MIL-PRF-39012D
AMENDMENT 4
10 July 2003
SUPERSEDING
AMENDMENT 3
16 July 2002

PERFORMANCE SPECIFICATION
CONNECTORS, COAXIAL, RADIO FREQUENCY
GENERAL SPECIFICATION FOR

This amendment forms a part of MIL-PRF-39012D, dated 13 July 1995,
and is approved for use by all Departments and Agencies of the Department of Defense.

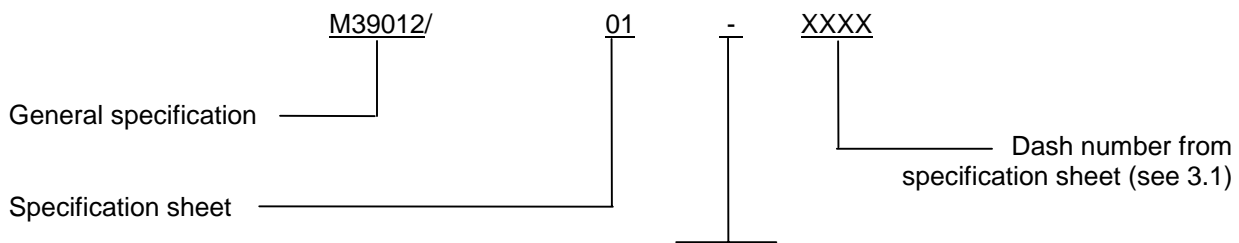
1.2.3 Part or Identifying Number (PIN). The PIN consists of the letter "M" followed by the basic specification sheet number, and a sequentially assigned four-digit dash number. The first digit in the dash number designates the material of the connector body (shell); i.e., "0" for brass, "3" for corrosion-resistant steel, or "4" for copper beryllium.

Example:

The "-" designates a standard military part. This position, when filled with the letter 'B' (i.e. M39012/01BXXXX), signifies a military part, which is for OEM use only. The part is assembled to the cable with special tooling. Acquisition of this type part by any agency other than OEM's is prohibited and will result in the substitution of the equivalent military replacement part (i.e., if "M39012/01BXXXX" is submitted for acquisition, "M39012/01-XXXX" will be recommended.)
